STAFF REPORT

APPLICANT: Eric Deters
DEVELOPMENT: Wendy's Restaurant
LOCATION: 319 Richwood Road
ZONING: Commercial Services (C-3)
DATE: January 10, 1991

The applicant is requesting a Variance in the number of free-standing signs to allow a third sign. The 3.04 acre site, located on the south side of Richwood Road and west of I-75, is zoned Commercial Services (C-3) and is owned by the Deters Company, Inc.

WP100
Pylon Sign

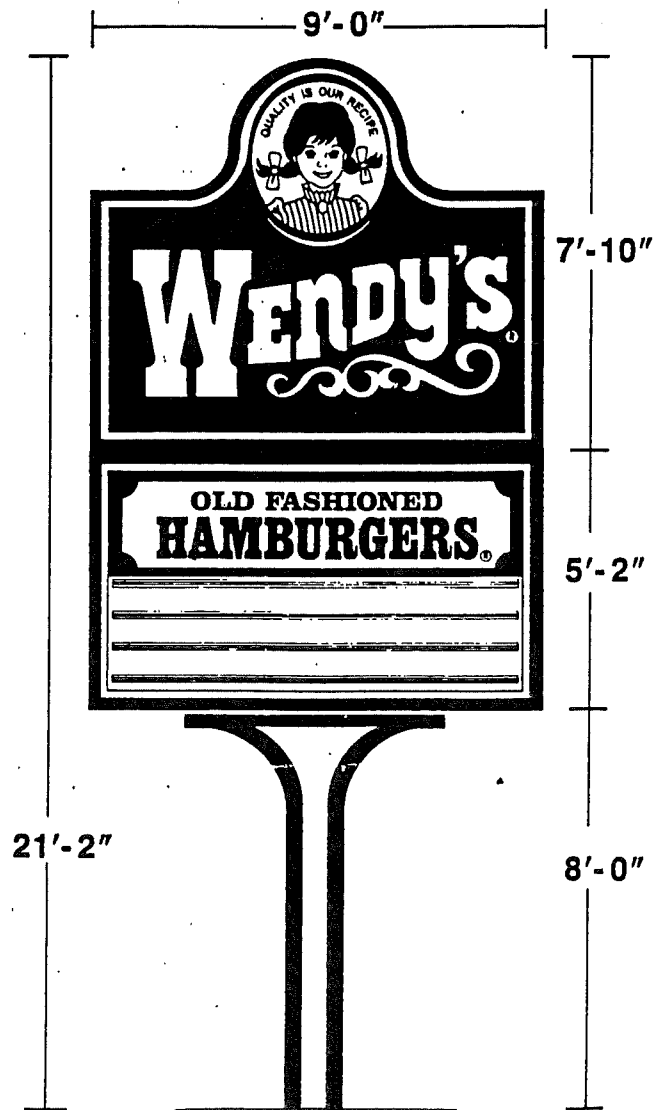
The applicant is requesting a Variance in the number of free-standing signs to allow the installation of the 100 square foot Wendy's entrance sign which was denied 8 months ago. The applicant's "Memorandum in Support of Variance Request of Deters Company, Inc." is attached, along with a drawing of the proposed sign and a site plan showing its intended location.
